### APPEAL SUMMARY

<b>Appeal ID:</b> 20216	<b>Project Address:</b> NWC - SW 1st Ave and SW Pine St
<b>Hearing Date:</b> 4/10/19	<b>Appellant Name:</b> Milena Di Tomaso
<b>Case No.:</b> B-014	<b>Appellant Phone:</b> 5038632425
<b>Appeal Type:</b> Building	<b>Plans Examiner/Inspector:</b> John Cooley
<b>Project Type:</b> lur	<b>Stories:</b> 5 <b>Occupancy:</b> B, M, S-1 <b>Construction Type:</b> 3-A
<b>Building/Business Name:</b> PAE Living Building	<b>Fire Sprinklers:</b> Yes - Throughout
<b>Appeal Involves:</b> Erection of a new structure, Reconsideration of appeal	<b>LUR or Permit Application No.:</b> 19-124284-LU
<b>Plan Submitted Option:</b> pdf [File 1]	<b>Proposed use:</b> Office, Retail

#### Appeal item 1

**FLOOR PLAN - LEVEL 04**  
1/8" = 1'-0"

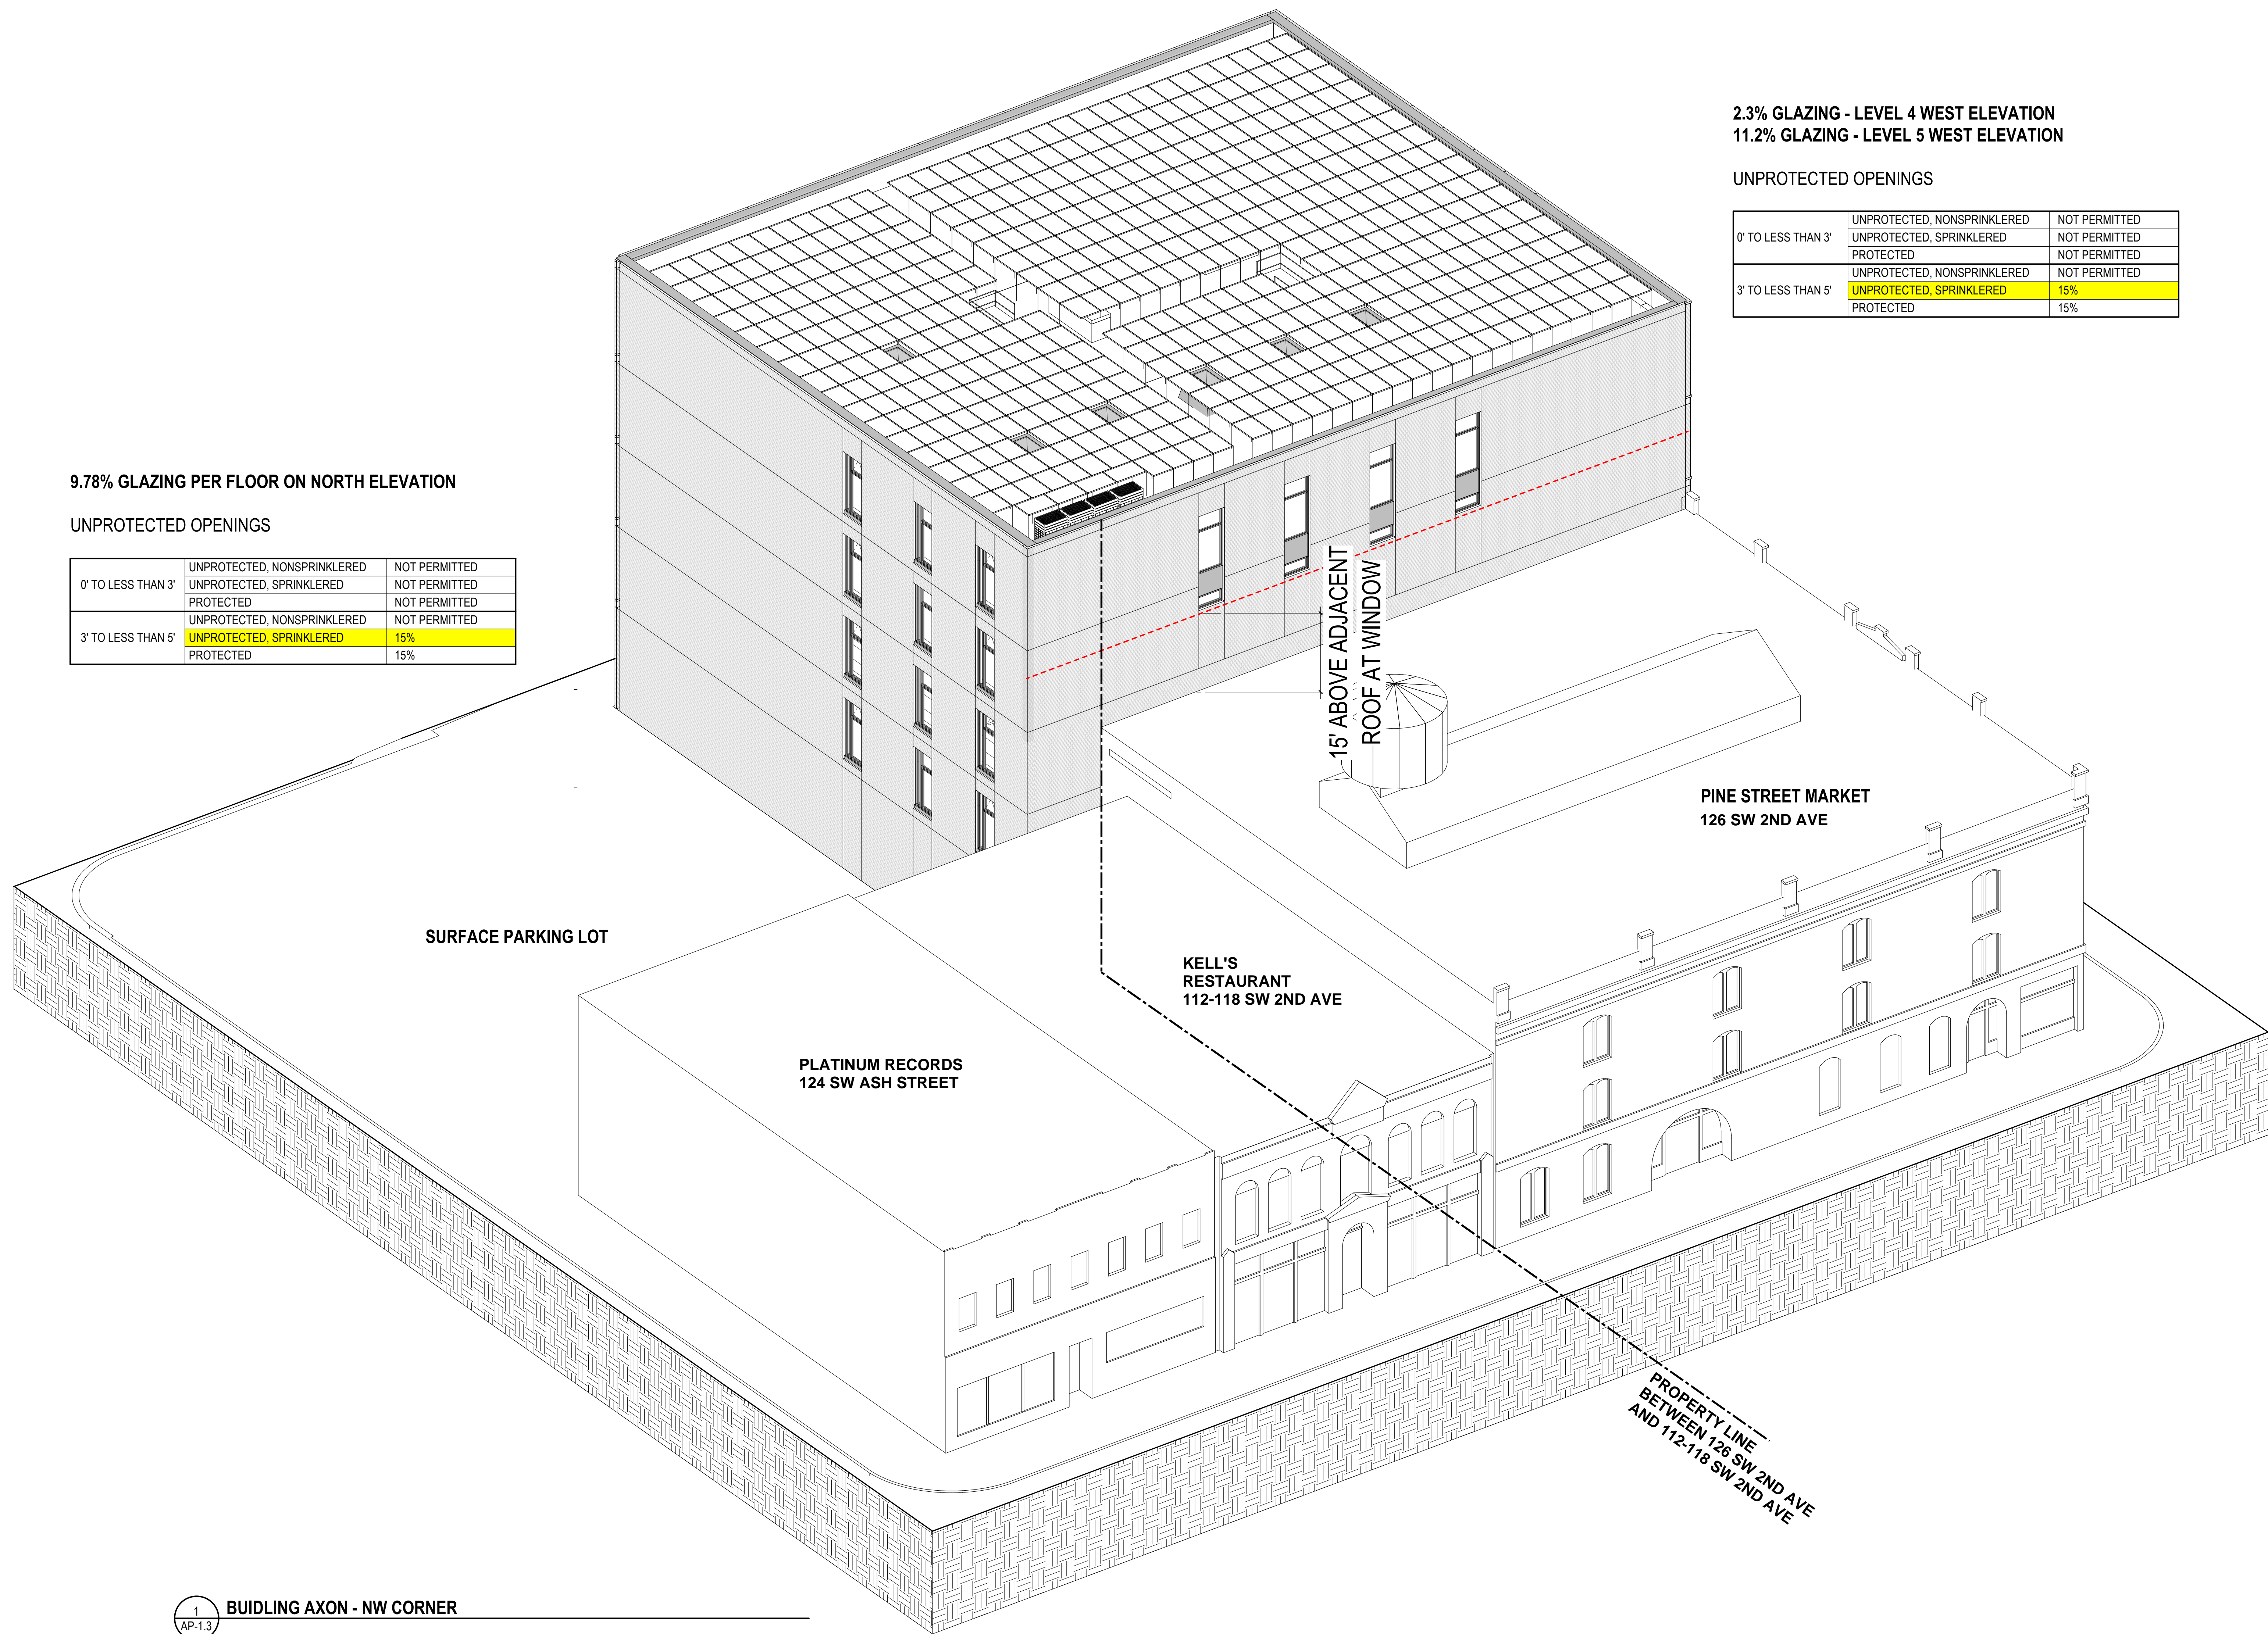
The proposed design locates a total of twelve (12) glazed operable openings on the second to fifth stories, built on the wall 8" off of the north property line facing the parking lot. A total of eight (8) glazed openings on the fourth and fifth stories are proposed to be built at the wall located 4" off the west property line and all are above the 15'-0" vertical from the rooftop of the existing adjacent building to the west. All the openings on the west are proposed to be fixed non-operable windows. Per 705.8.6.2, the west window openings are above 15' from the adjacent roof and will not require any protective rating.

The proposed design locates a total of twelve (12) glazed operable openings on the second to fifth stories, built on the wall 8" off of the north property line facing the parking lot. A total of eight (8) glazed openings on the fourth and fifth stories are proposed to be built at the wall located 4" off the west property line and all are above the 15'-0" vertical from the rooftop of the existing adjacent building to the west. All the openings on the west are proposed to be fixed non-operable windows. Per 705.8.6.2, the west window openings are above 15' from the adjacent roof and will not require any protective rating.

No-build easements will be established between the north parking lot property and the west Pine Street Market property that will prevent any future developments on those lots to occur within the code required fire separation distance. Per Table 705.8, the fire separation distance shall be between 3'-0" and up to 5'-0" when there is up to 15% of unprotected opening area in the exterior wall of a sprinklered building. We have less than 15% unprotected openings on both the north and west elevations and are proposing a 3'-0" no-build easement as shown on the attached site plan. In addition, a covenant will be established between the two adjoining properties to state that in the

Note: No easement will be established between Kell's Restaurant property, as there are no proposed openings on that portion of the shared property line. The unprotected opening area percentage, on the West, is calculated based on the length of the building at the Pine Street Market property line only.

**1a. Openings in the North wall within 3 feet of the property line with no build easement: Granted provided the easement is a minimum of 2 feet, 4 inches wide for the full width of the building.**

4  
AP-1.5  
SECTION, WALL - WEST AT OPENINGS  
1/2" = 1'-0"

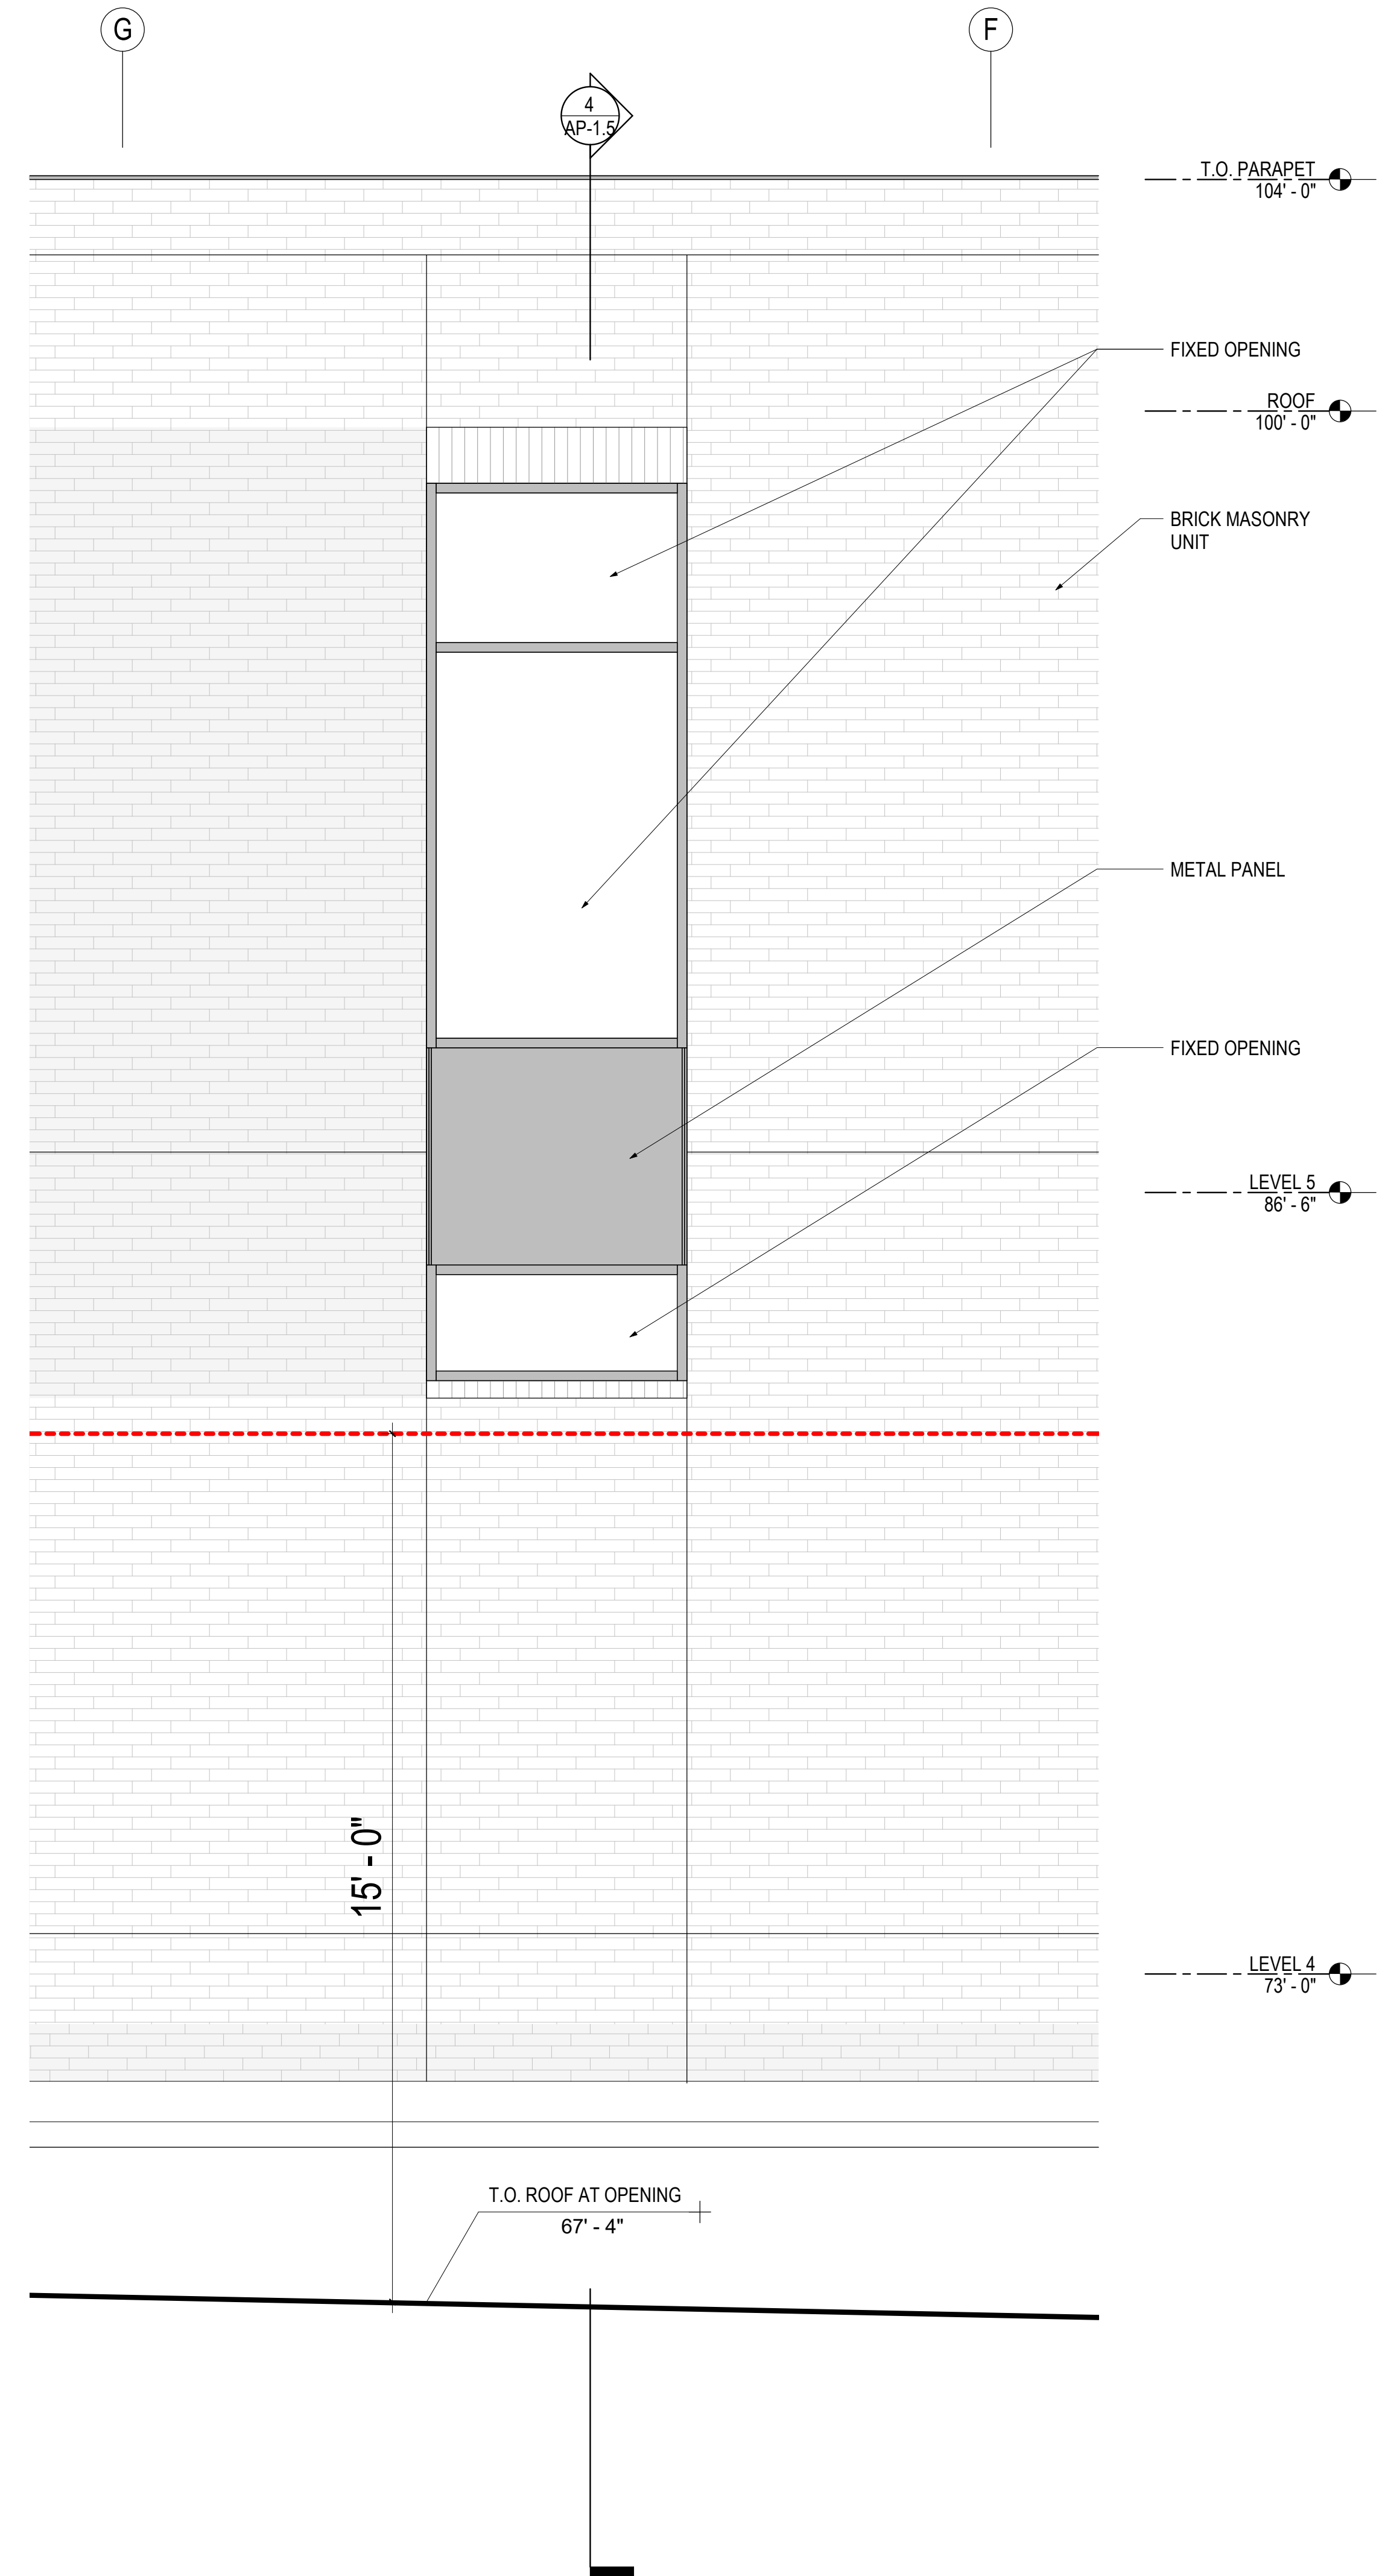
All proposed window openings on the west elevation are above the 15'-0" vertical separation distance from the adjacent roof structure on the west. All window openings will be unprotected. This proposed alternate is required for the project to meet its targeted certification under the Living Building Challenge. The "Civilized Environment" Imperative requires all workspaces (at the time of certification) to be within 30' of a window and/or manually operable mechanism to provide fresh air and daylight. Without the proposed windows, the building would not be economically viable as an office, as too much of the floor plate could not be regularly occupied as workspace; the project is already being zoned and designed with circulation, mechanical and office support spaces in "non-daylit" zones on the first, second, and third floors. As well, skylights are considered on the fifth floor, but they are limited in area so not to conflict with the necessity to maximize PV placement and renewable energy production to achieve the required net-zero energy performance under LBC, as well the necessity to provide fire department access and circulation around the perimeter of the roof.

All proposed window openings on the west elevation are above the 15'-0" vertical separation distance from the adjacent roof structure on the west. All window openings will be unprotected.

**1b. Openings in the West wall within 3 feet of the property line with no build easement above the roof of the adjacent building: Granted provided the easement is a minimum of 2 feet, 8 inches wide x 100 feet in length for the full length of the adjacent Pine Street Market building.**
